TURBO AFTERMARKET Service Bulletin

New Retrofit Actuator for Ford V2S and HP Turbos

February 12, 2018 | S-02-18

6.4 liter V2S and HP stage Actuator Replacement

See *Figure 1*

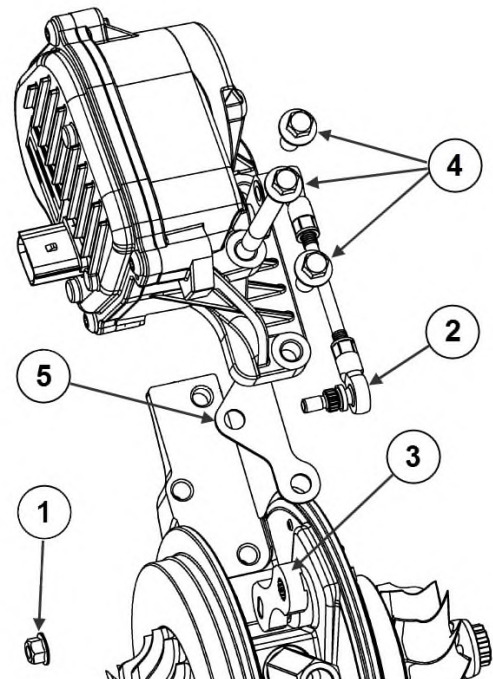
1. Remove M6 nut (1) and separate linkage (2) from dog-bone (3)
2. Disconnect two coolant hoses from SRA
3. Disconnect electrical connector from SRA
4. Remove three M8 bolts (4)
5. Remove SRA Assembly and thermal spacer (5) from turbocharger
6. Properly discard SRA Assembly and hardware

Figure 2 - CBA

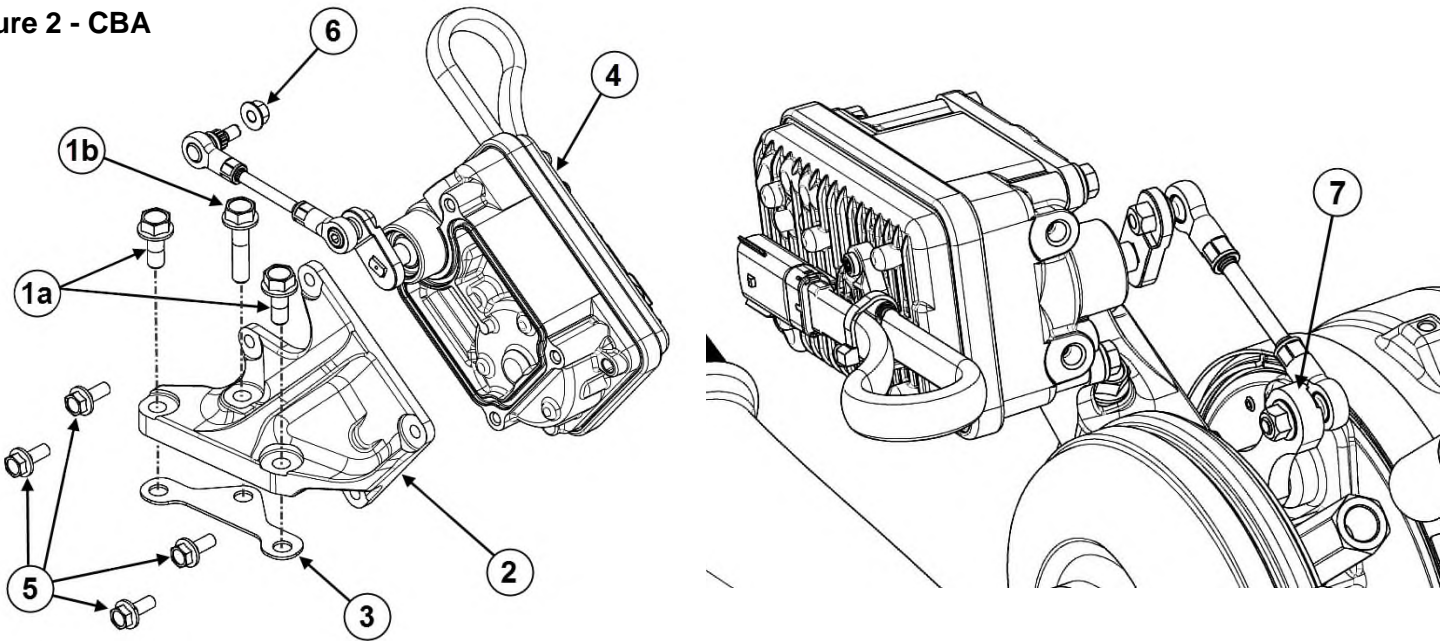
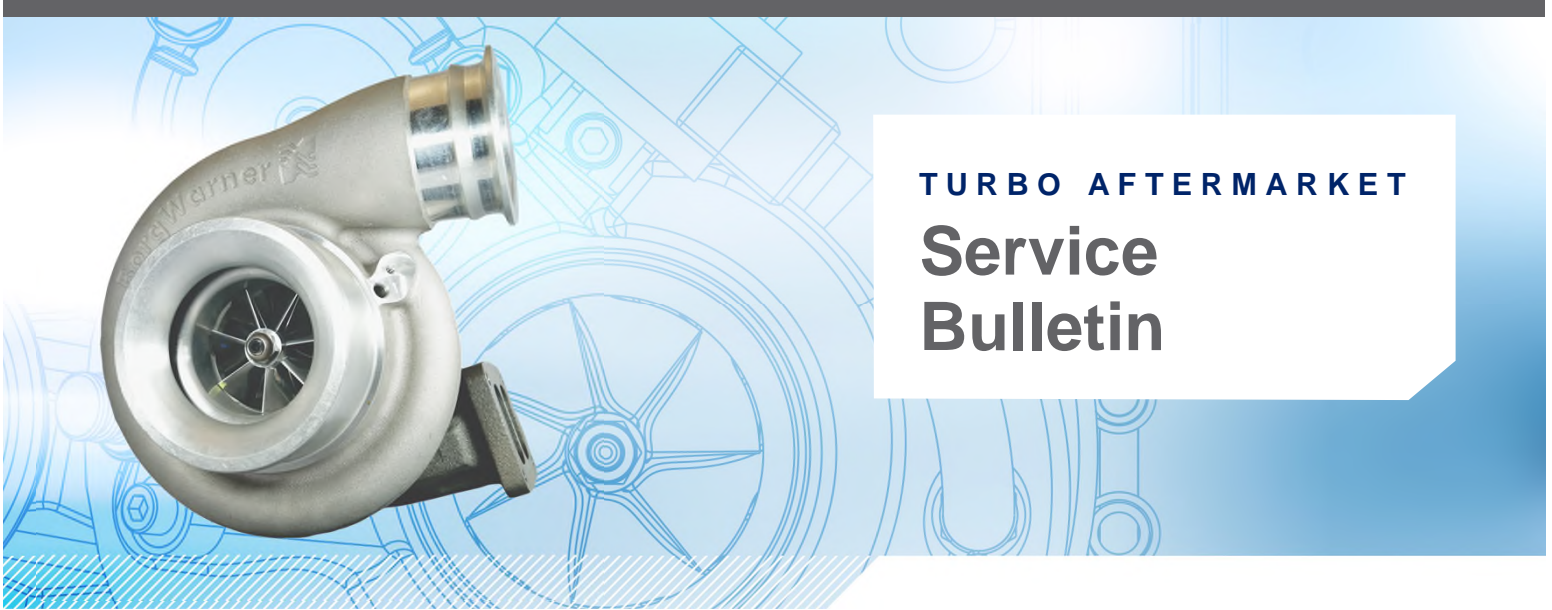
1. Mount the thermal spacer (3) and Actuator bracket (2) to the turbocharger bearing housing using the supplied M8 bolts (1a,1b), ensuring proper orientation of thermal spacer. Torque the three M8 bolts to 19±1 Nm.
2. Insert Actuator linkage end into dog-bone (7) and loosely secure with M6 nut (6) by hand
3. Install Actuator assembly (4) to bracket (2) using the four supplied M6 bolts (5) and tighten to 13.5±1.1 Nm
4. Tighten M6 nut (6) to 10.5±0.3 Nm

Photo #1 below shows the original actuator and coolant line arrangement and Photo #2 shows the new actuator with the coolant line rerouted directly to the coolant reservoir.

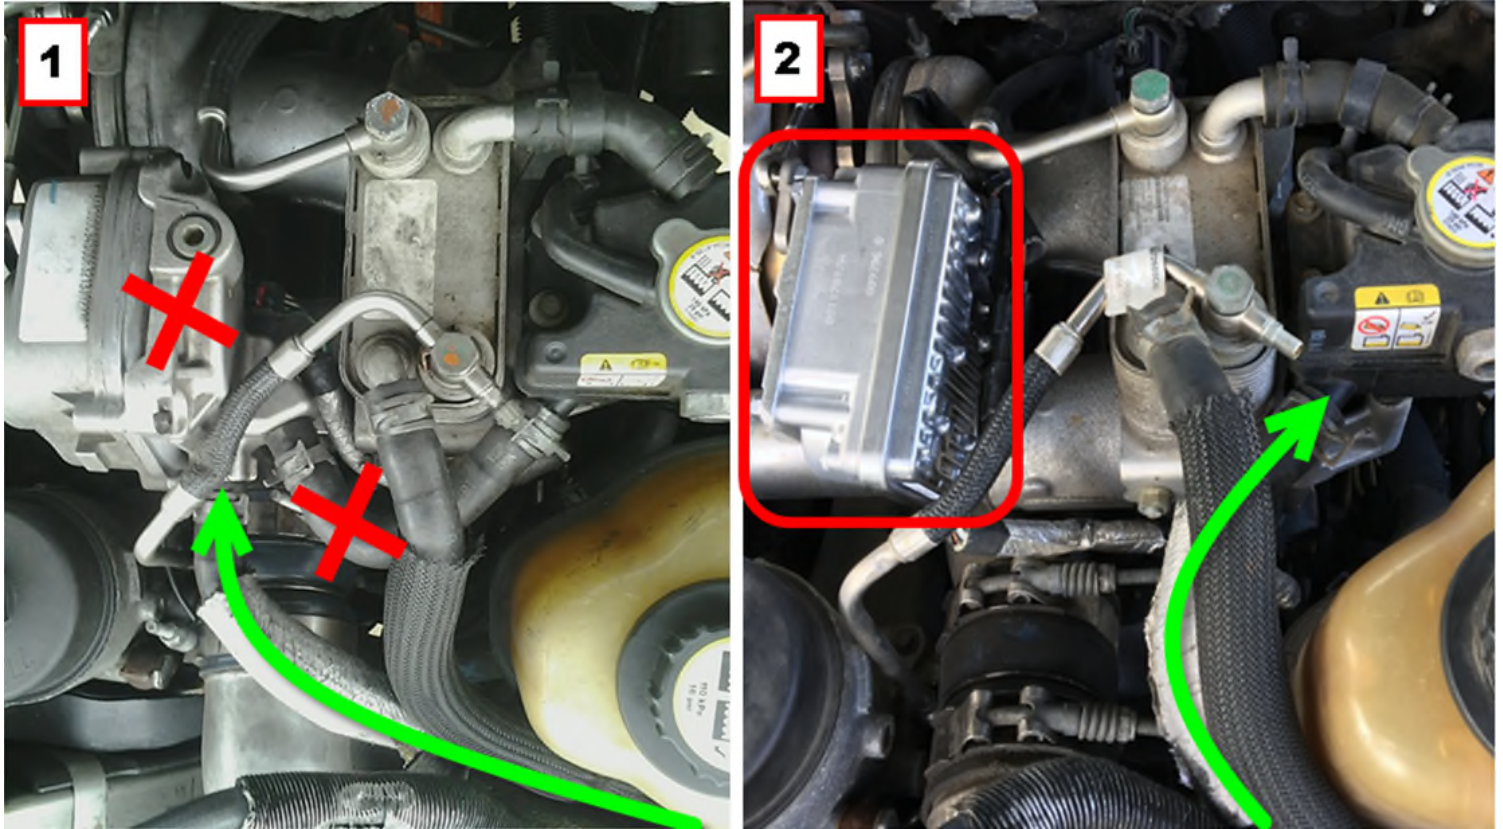
The coolant block attached to the original SRA actuator and the short hose connecting the coolant block to the reservoir will no longer be used. See red **X**'s in photo #1 above.

The shielded hose marked with the green  will move from the coolant block connection shown in photo #1 and go directly to the reservoir connection as shown in photo #2.

The new CBA retrofit actuator does not require water cooling as did the original SRA. The existing coolant lines can be rerouted to bypass the actuator and complete the cooling circuit without modification by eliminating the actuator coolant block and the short hose that went from the old actuator coolant block to the reservoir.
